**15-DAY EXPRESS TERMS
FOR
BUILDING STANDARDS
OF THE
CALIFORNIA STATE LANDS COMMISSION**

**REGARDING AMENDMENTS TO THE 2010 CALIFORNIA BUILDING CODE,
CALIFORNIA CODE OF REGULATIONS, TITLE 24, PART 2
MARINE OIL TERMINALS, CHAPTER 31F**

FIGURE 31F-2-1

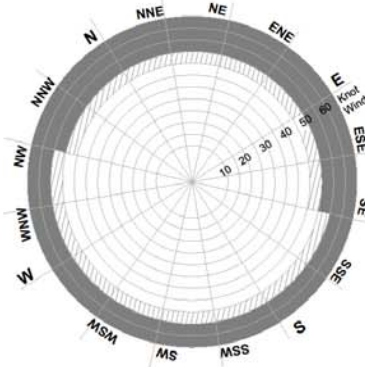
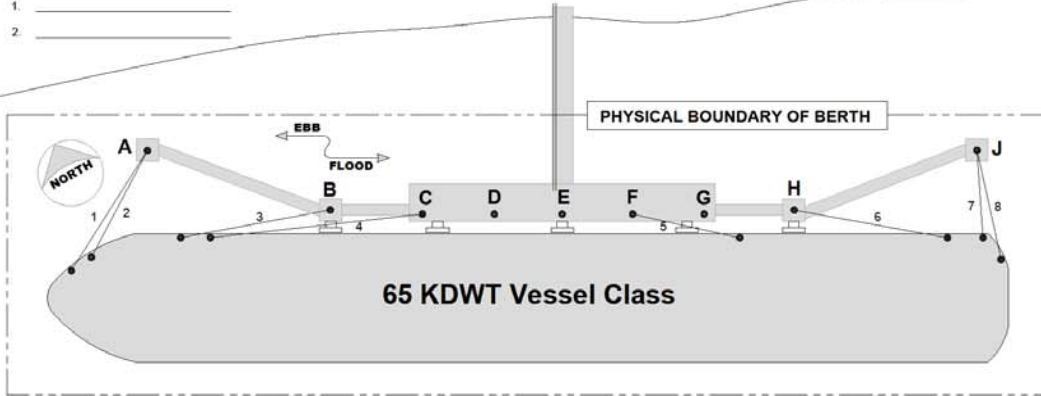
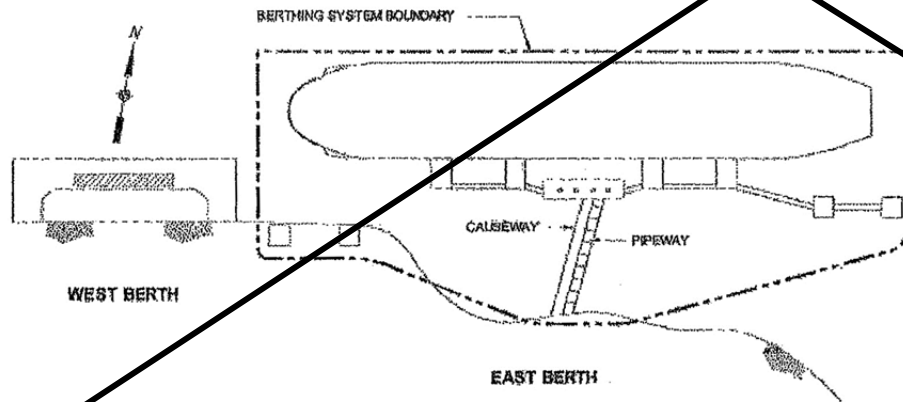
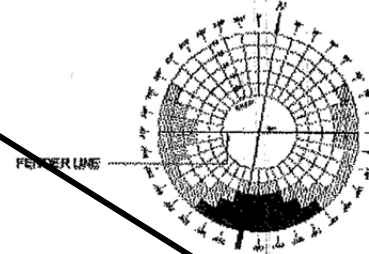
Based on public comment, the proposed language is amended as specified in the following five items:

- (1) **“GENERAL INFORMATION”** – Addition of “(S)” following “CALCULATION”, “REPORT”, “PREPARER” and “DATE” (4 total), and modification of “ALTERNATIVES” TO “ALTERNATIVE(S)” to correct these typographical errors.

- (2) Modification of **“PHYSICAL BOUNDARY OF BERTHING SYSTEM”** label to **“PHYSICAL BOUNDARY OF BERTH”** to remove the potential for misunderstanding, as “berthing systems” may extend beyond the example boundary shown.

- (3) **“ENVIRONMENTAL CONDITION LIMITS”** – Modification of example current angle statements so that the current directions generally align with the face-of-wharf and ebb-flood arrows.

- (4) **“BERTH DESCRIPTION:”** – Addition of “MINIMUM” before “WATER DEPTH” and removal of “MINIMUM WATER DEPTH 38.0 FT”, as these example statements introduced greater confusion than benefit.

- (5) **“BERTH NOTES:”** – Removal of item #4, as this example statement introduced greater confusion than benefit.
